CITY OF HAYWARD

AGENDA REPORT

SUBJECT: Variance No. PL-2003-0462 – Marlene Milani (Applicant)/ Julio and Rubi Magana (Owner) – Request for a Variance to Allow a Garage with a 14-Foot Front Setback Where 20-feet Is Required and a 3'-10" Side Yard Setback Where 6'-8" Is Required.

The Property Is Located at 24025 Second Street In a Single-Family Residential (RS) District

1ST FLOOR PLAN-EXISTING AND ADDITION

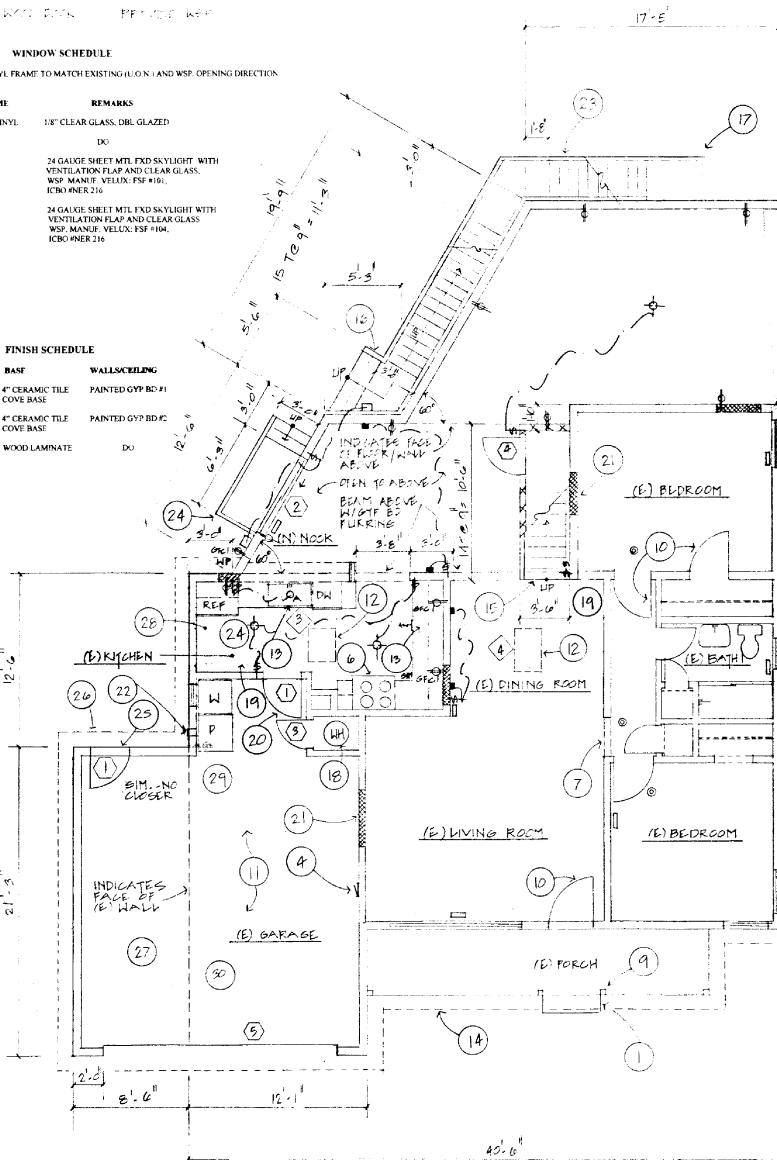
The applicant has a single-car garage that is only 14 feet from the front property line. He proposes to meet the requirement for a two-car garage by extending the existing garage to toward the side to within 3'-10" feet from the side property line. However, because a front yard setback of at least 20 feet is required and a side yard setback of at least 6'8" is required, approval of a variance is necessary to construct the garage.

Staff does not support this application for safety reasons. The required 20-foot setback between the garage and the front property line is required in order to accommodate additional parking without cars extending into the public right-of-way and hindering pedestrian circulation. In addition, staff has observed that on-street parking is limited in the area, including in front of the subject property, as many of the tenants in the surrounding apartment complexes park on the street. There is also a weekly parking restriction for street cleaning, further limiting on street parking. Any additional cars, over the two cars parked in the garage, may have to be parked on the opposite side of the street, thereby requiring the crossing of Second Street, a busy arterial street, further contributing to an unsafe situation.

NORTH ELEVATION

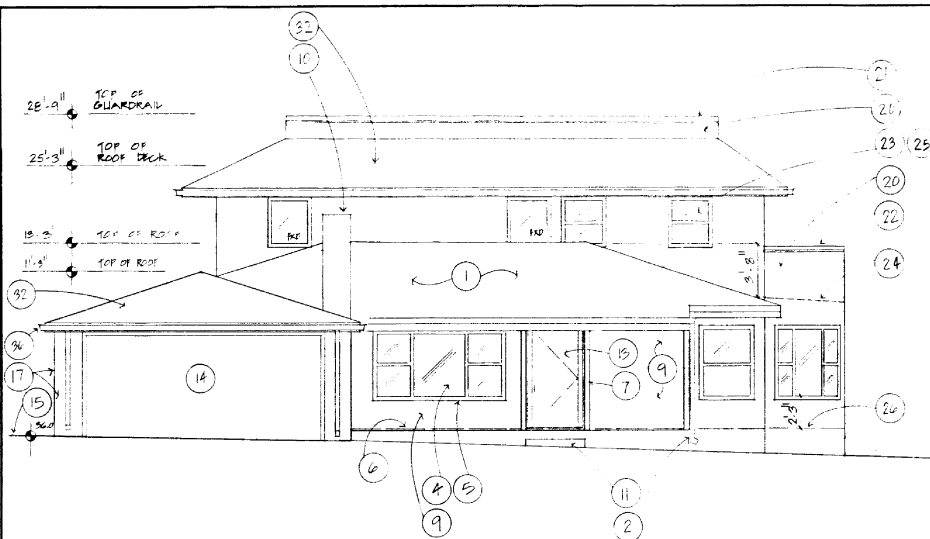
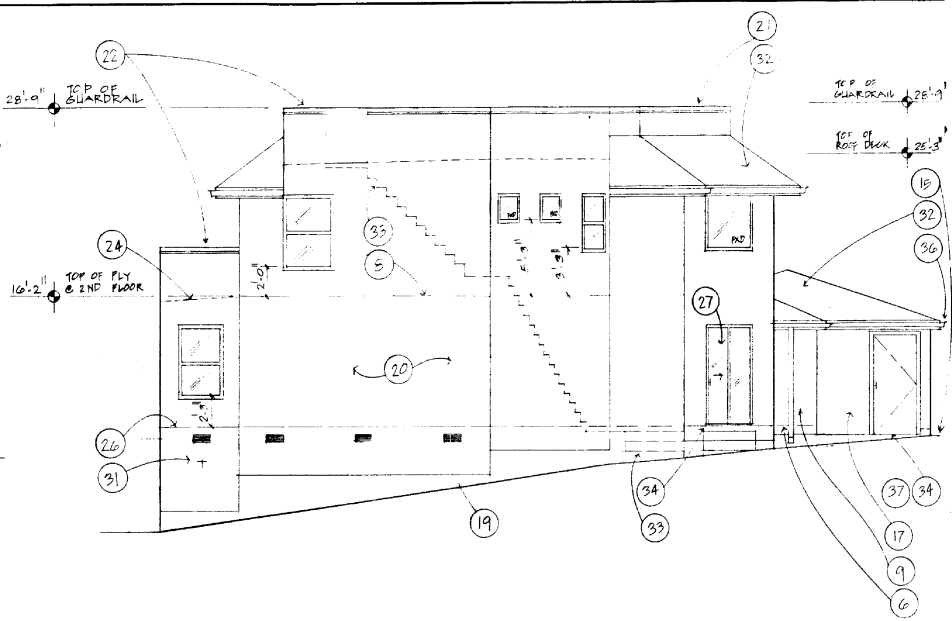
With regard to design, the proposed addition is not appealing and does not meet the City's Design Guidelines in that it is not harmonious with the existing house nor does it blend in with the single-family dwellings in the surrounding area. The addition and existing house appears as two separate buildings. The roof style differs in that the existing house has a gable roof and the addition has a partial mansard roof. The rear of the addition appears more like an apartment complex rather than a single-family dwelling with its boxy shape and stairs leading to the roof deck. Furthermore, the roof deck would impinge on the privacy of the adjacent apartment tenants in that from the proposed roof deck and stairway, one could look directly into the living rooms and bedrooms of the adjacent apartments. There could also be an issue of loss of privacy relative to the back yards of the small lots on Acacia Drive.

If the Planning Commission is supportive of the variance, appropriate findings and conditions of approval must be adopted and consideration be given to improving the design of the addition and for the privacy of the residents on adjacent properties.
